**Submittal No.:** 04c: Containment Plans Rev 2, Pages C8A & C11A

**Description:** Proposal/Contract Number: Bennington-Mt Tabor BF BPNT (16)  
Letting Date: 06/05/15; Award Date: 07/01/15  
Project Description: Bridge Painting of Five Bridges  
In the Towns of Bennington & Mt. Tabor, VT  
Contract Amount: \$2,122,323.00; Completion Date: 09/02/16

**Revision:**  
**We have added the use of fence platform in conjunction with the corrugated platform for bridges 15 and 16N & S. These pages are shown on C8A & C11A. Note that only corrugated platform will be used over live lanes.**

ABRASIVE BLASTING  
CONTAINMENT PLANS, REV. 3

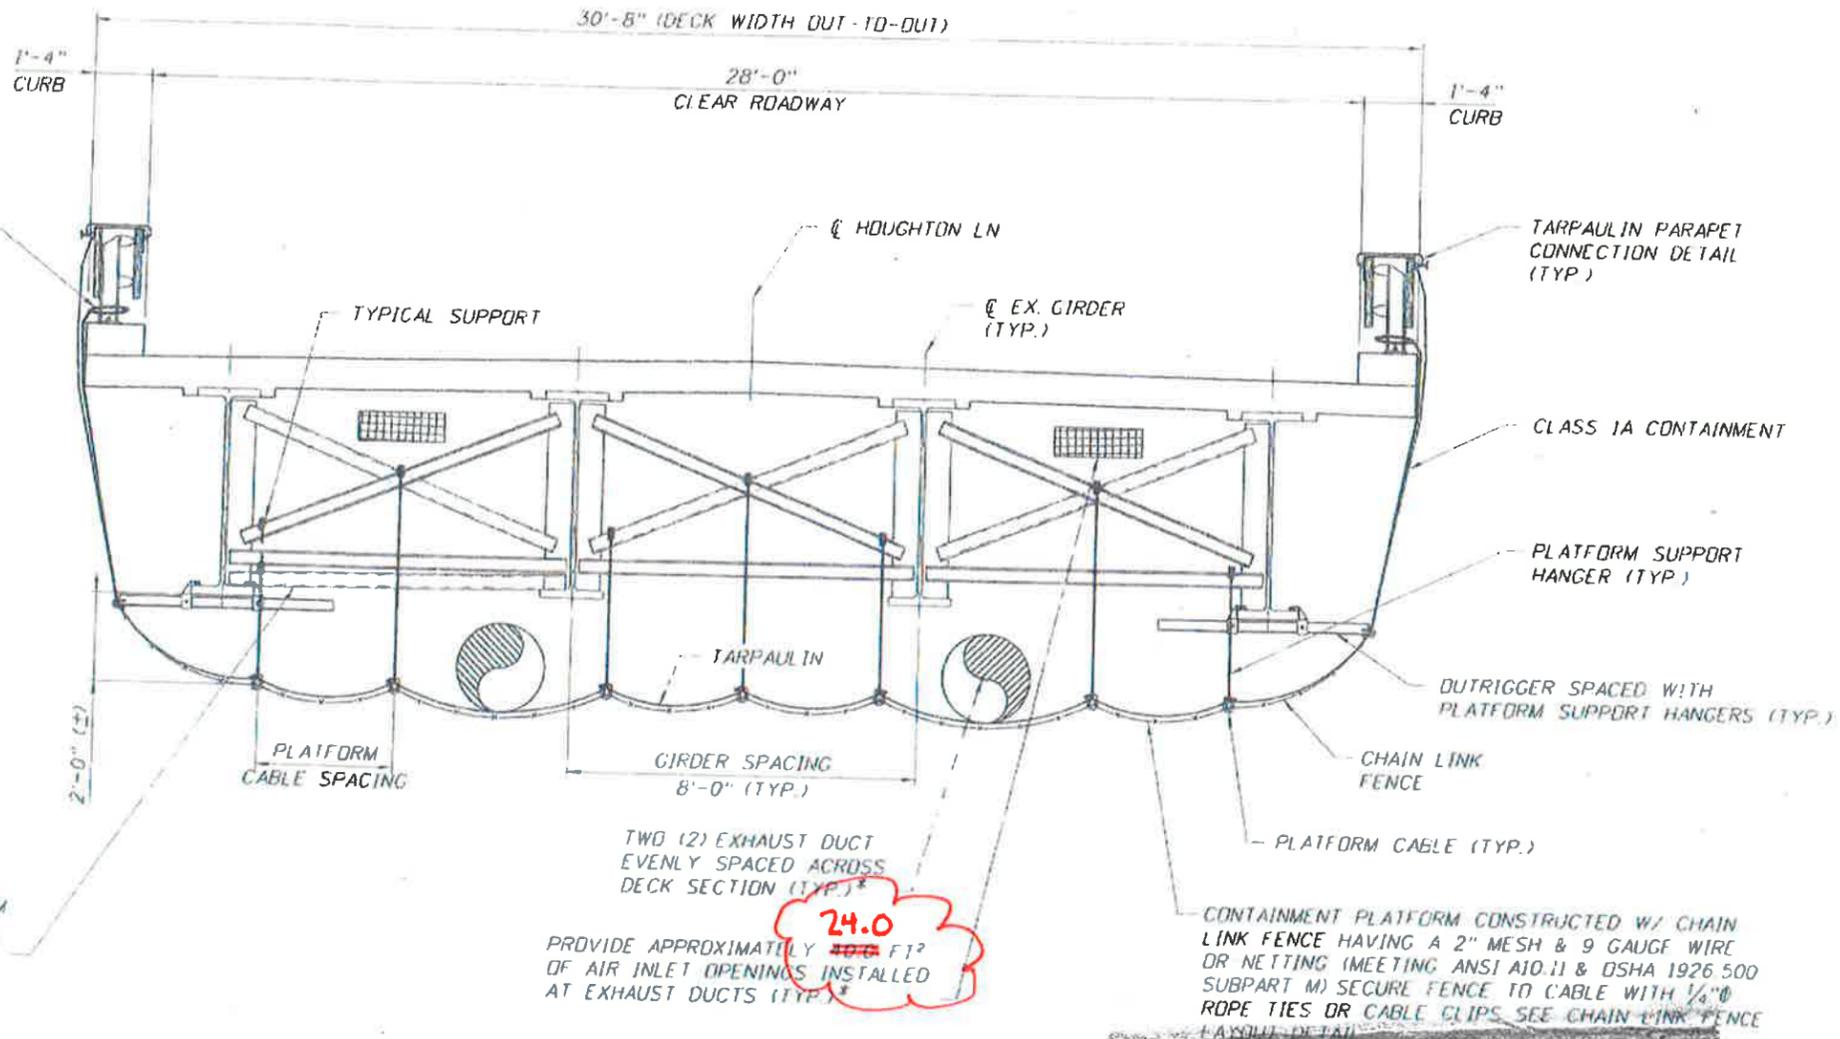
TWO (2) EXHAUST DUCT EVENLY SPACED ACROSS DECK SECTION (TYP.)  
 PROVIDE APPROXIMATELY ~~20.0~~ **24.0** FT<sup>2</sup> OF AIR INLET OPENINGS INSTALLED AT EXHAUST DUCTS (TYP.)

CONTAINMENT PLATFORM CONSTRUCTED W/ CHAIN LINK FENCE HAVING A 2" MESH & 9 GAUGE WIRE OR NETTING (MEETING ANSI A10.11 & OSHA 1926.500 SUBPART M) SECURE FENCE TO CABLE WITH 1/4" ROPE TIES OR CABLE CLIPS SEE CHAIN LINK FENCE LAYOUT DETAIL

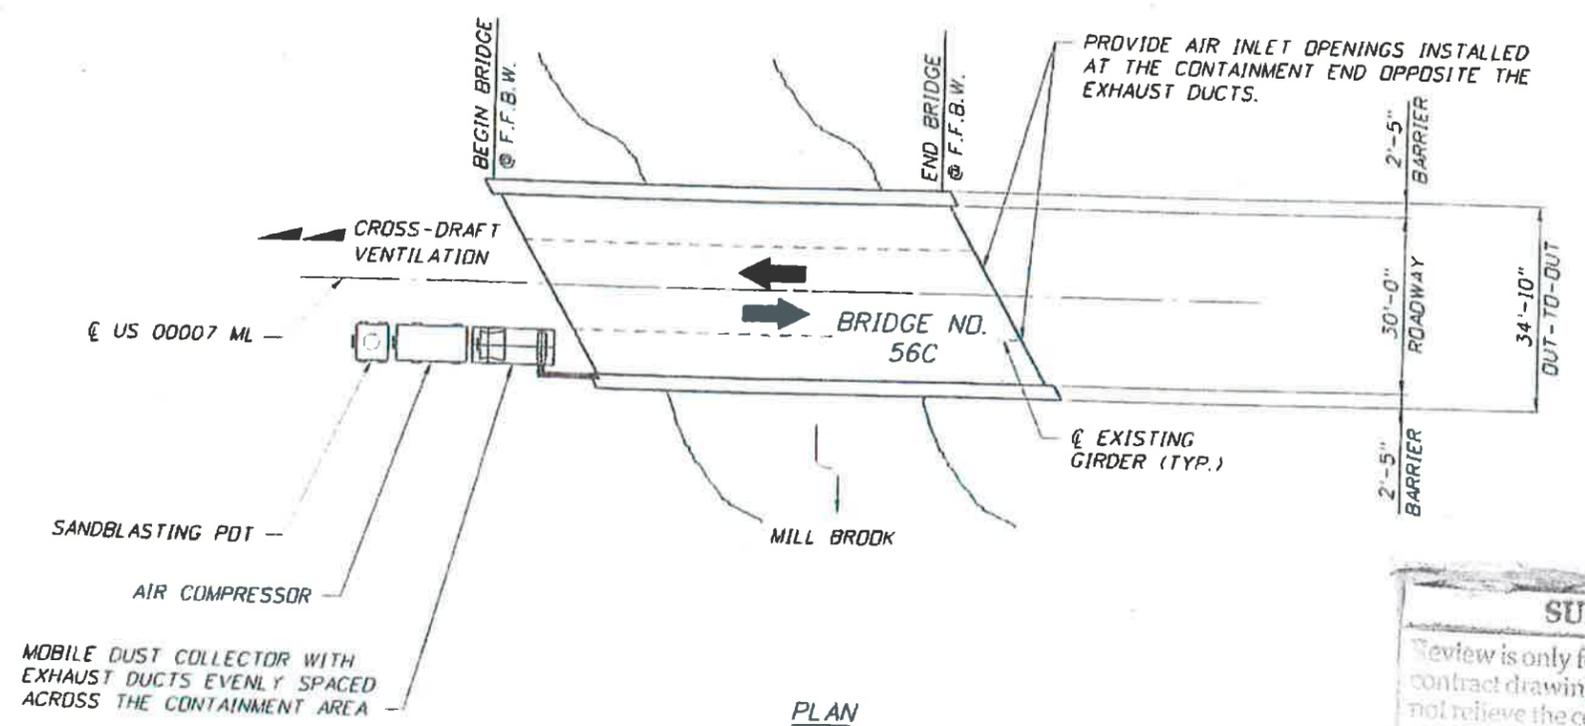
CONTAINMENT PLATFORM CONSTRUCTED W/ CHAIN LINK FENCE HAVING A 2" MESH & 9 GAUGE WIRE OR NETTING MEETING ANSI A10.11 & DSHA 1926.500 (PART 1) SECURE FENCE TO CABLE WITH 1/4" DIA. TIES OR CABLE CLIPS. SEE CHAIN LINK FENCE LAYOUT DETAIL.
